WATER QUALITY MEMORANDUM Utah Coal Regulatory Program

TO: Internal File
THRU: Steve Christensen, Permit Supervisor *SLC*
FROM: Ken Hoffman, Environmental Scientist *KH*
RE: 2011 First Quarter Water Monitoring, Canyon Fuel Company, LLC, C/007/0005, Task ID #3758

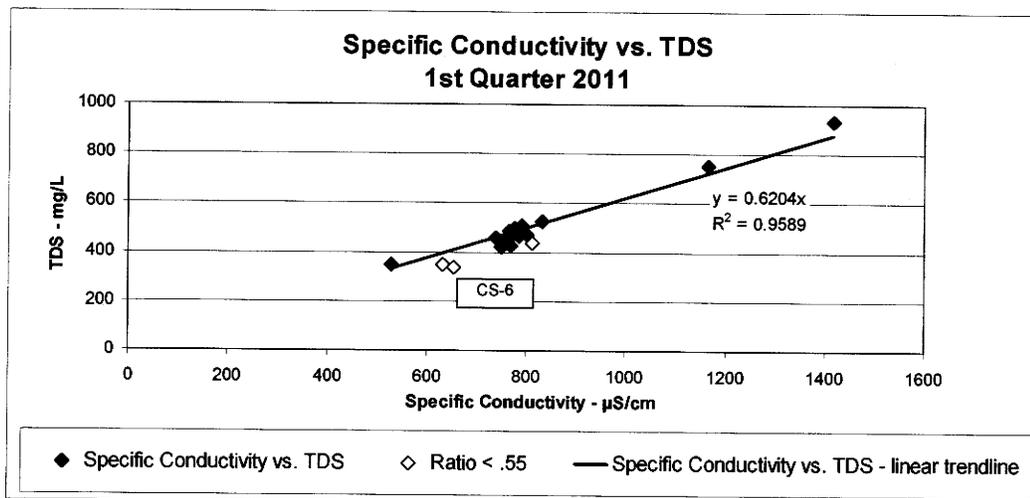
- TDS/Conductivity
 - Out of 21 samples for which both field specific conductivity and TDS were determined, 18 have a TDS/Conductivity ratio in the expected range between 0.55 and 0.76.
 - CS-6 is just outside that range, at 0.52.
 - The linear trendline has a slope of 0.62 (see chart).
 - UPDES discharges account for 15 of the 21 samples.
